Somerville Chamber of Commerce 2 Alpine Street, P.O. Box 440343 Somerville MA 02144 617-776-4100

July 23, 2010

RE: EEA #13886

The Somerville Chamber of Commerce values the opportunity to comment on the Final Environmental Impact Report (FEIR) for the Green Line Extension (GLX) project. We also appreciate your efforts and those of the Massachusetts Department of Transportation (MassDOT) to move this project forward consistent with the Commonwealth's transit commitments and goals. The Chamber has been a champion of restoring urban transit to New England's most densely populated city -- the city that is closer downtown Boston than most of the City of Boston and in the center of the Brainpower Triangle of MIT, Harvard and Tufts.

OPTION L BET

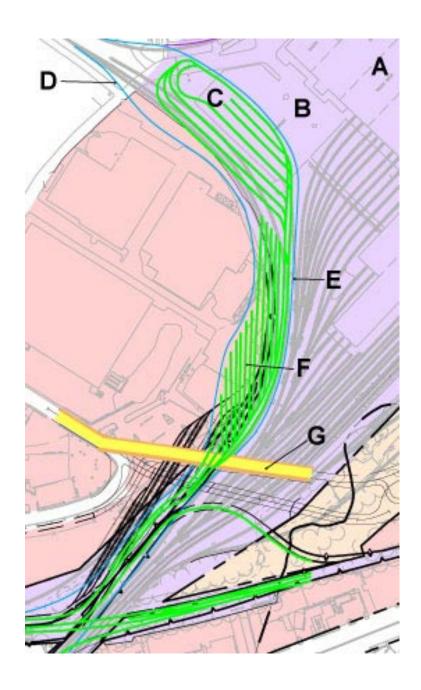
In the meantime, we are encouraged by efforts of a lone, independent engineer, Stephen Kaiser, who has been sending MassDOT his feasibility plan. "Option L BET" uses MBTA land and minimizes takings. It appears to be remarkable for the potential to satisfy requirements at a lower taxpayer cost and on a faster timeline. This concept has a logical zoning of employee parking, the maintenance facility, and vehicle storage.

Option L BET is along the northwest fringe of the MBTA's Commuter Rail maintenance facility, also referred to as the Boston Engine Terminal (BET). Option L BET is immediately adjacent to the southern and southeastern fringe of the existing Inner Belt business district of Somerville. The layout of yards and buildings is in an "L" shape and is between the relocated Wiley Track and CSX Grand Junction track just west and northwest of the MBTA's BET.

The maintenance building and associated track work are proposed on land within relocated Valley Tracks on part of the existing BET surface parking lot next to the BET facility. The vehicle storage yard is proposed southwest of the GLX maintenance building on land within the relocated Valley Tracks.

The layout of Option L BET includes one storage yard and the maintenance building. The yard is immediately south of 70 Inner Belt Road. This yard includes fifteen storage tracks and a runaround track. The yard would store up to 67 cars. For Option L BET, 13 cars would need to be stored in the building or tracks just outside the buildings at any given time in order to meet program storage requirements.

To provide double-ended access to the maintenance building, a loop track is added which provides access to the north side of the building from a runaround track to the east of the building and the south storage yard.

Option L BET would not impact Pan Am Railways' freight operations to the same degree as Option L and Yard 8. Option L BET would not require the removal of the Wiley Track which connects the south end of Yard 8 to the Valley Tracks. With the Wiley Track preserved, M.S. Walker, a current freight customer of Pan Am Railways, is a business that would not have to be relocated to make room for the Green Line maintenance facility. Option L BET would not have any impacts on revenue passenger operations or on operations associated with the MBTA (e.g., vehicle storage and maintenance, maintenance-of-way). Option L BET would have no impacts on existing CSX operations between the Grand Junction Branch and the Valley Tracks. Option L BET would not preclude the future North-South Rail Link project. Option L BET would limit the ability to expand the BET facility within existing MBTA property limits.

Option L BET would require only partial acquisition of two parcels. The land required for the yard and maintenance facility includes land and some parking at 20 Third Avenue; and the isolated parking lot for 70 Inner Belt Road. This alternative requires the acquisition of approximately 3.2 acres of land which has been estimated at approximately \$4 million (including site cleanup). This cost could be refined with additional research. These acquisitions would represent a minimal loss of current tax revenue to Somerville as the MBTA is exempt from local property taxes. This alternative could minimize the loss of current and potential tax revenue which would be generated by future development at this location.

The Chamber requests a supplemental FEIR of limited scope in consideration of Option L BET or similar BET site to ensure MassDOT's compliance with the various factors, laws, executive orders, and policies cited above. A focused and speedy supplemental FEIR would ensure a more public, transparent, and thorough analysis of vehicle storage and maintenance solutions within existing, publicly-owned land area. The definition and composition of the Design Working Group (with consideration of Chamber representation) would facilitate and advance such action and would not be grounds for further GLX project delay.
